ENGINEERING PRACTICE (EP) STUDY

TITLE: Proposed New Class Y (Non-Hermetic Microcircuits For Space Application)
Requirements For MIL-PRF-38535.

Study project number: 5962-2011-006

FINAL REPORT

(For an example of typical flip chip device, please do not use this figure to justify Class Y device.)

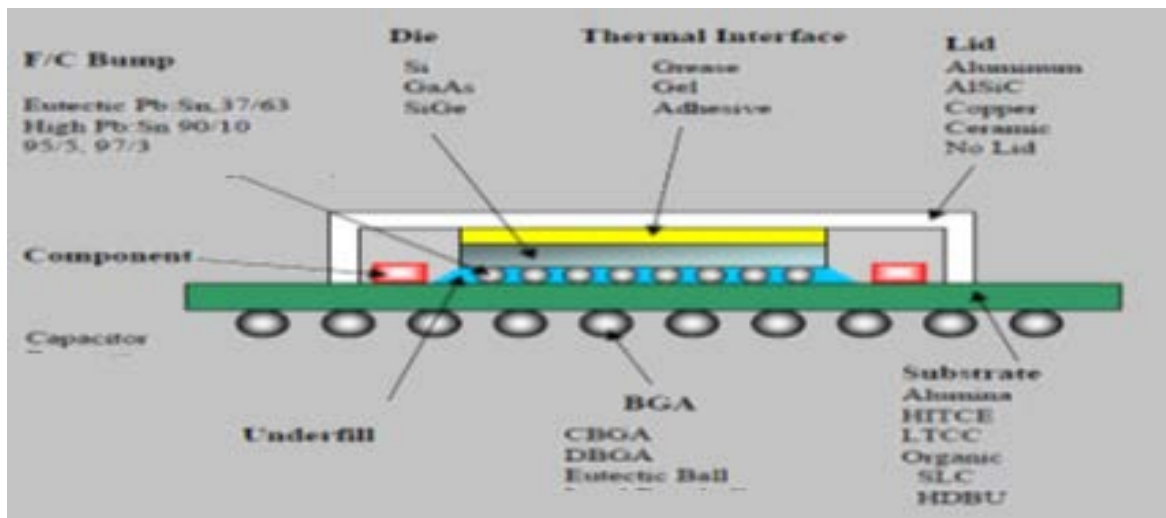
1. Board level testing for BGA/CGA package.

2. Underfill and/or thermal grease/epoxy to expose in atmosphere moistures:

3. Electrical tests after column/ball attach at -55/ 25/125°C

- ❖ Board level testing is totally beyond the scope of MIL-PRF-38535.

- ❖ The under fill material and lid attach epoxy shall meet TM5011
- ❖ Must be addressed in the package integration demonstration test plan (PIDTP)
- ❖ HAST test shall be performed for moisture resistance of the under fill and lid attach materials.
- ❖ Both X-ray and CSAM should be performed on underfill as they detect different types of defects.

- ❖ Electrical test shall be performed across the full temperatures ranges prior to attach ball/columns on the package to ensure bumps/solder/epoxy integrity.
- ❖ After ball attach (BGA package) electrical test shall be performed across the full military temperatures ranges.
- ❖ After column attach (CGA package) electrical test shall be performed at 25°C as a minimum to verify no electrically/mechanically damage have been introduced due to the attach process.
